## SERVICE INFORMATION BULLETIN

**APPLICABILITY:** 2017-2018MY Impreza  
2018MY Crosstrek

**NUMBER:** 07-141-18

**SUBJECT:** Engine Harness Retaining Clip Change

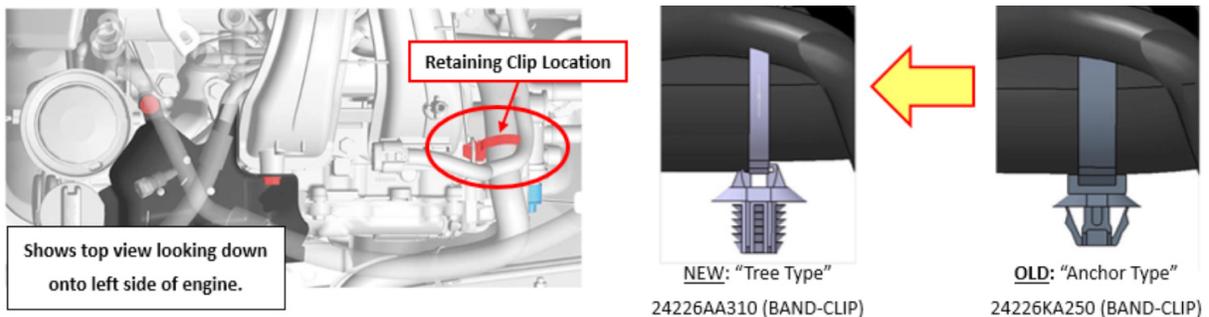
This Service Information Bulletin announces a change to the retaining clip used to secure the engine harness on the models listed above. The change to a “Tree Type” clip from an “Anchor Type” was made to secure the harness tighter and improve assembly line productivity. Comparison images are provided below.

In a RARE case where the harness clip requires replacement, the new part number is: **24226AA310**.

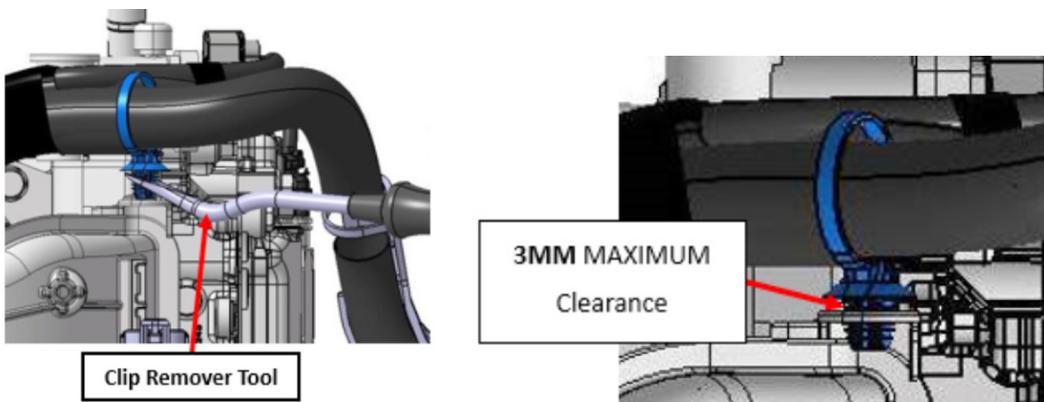
- Whenever removing the clip from the mounting bracket, ALWAYS use a clip removal tool as shown in the illustrations below to avoid damaging it.
- When installing the clip, it must be inserted into the bracket firmly with no more than 3MM clearance between the bracket and the underside of the clip.

**NOTE:** If the clip is replaced, put a reference mark on the harness before removing the original so the new clip can be positioned properly. After tightening the band of the new clip around the harness, trim off any excess (5mm max.) band remaining.
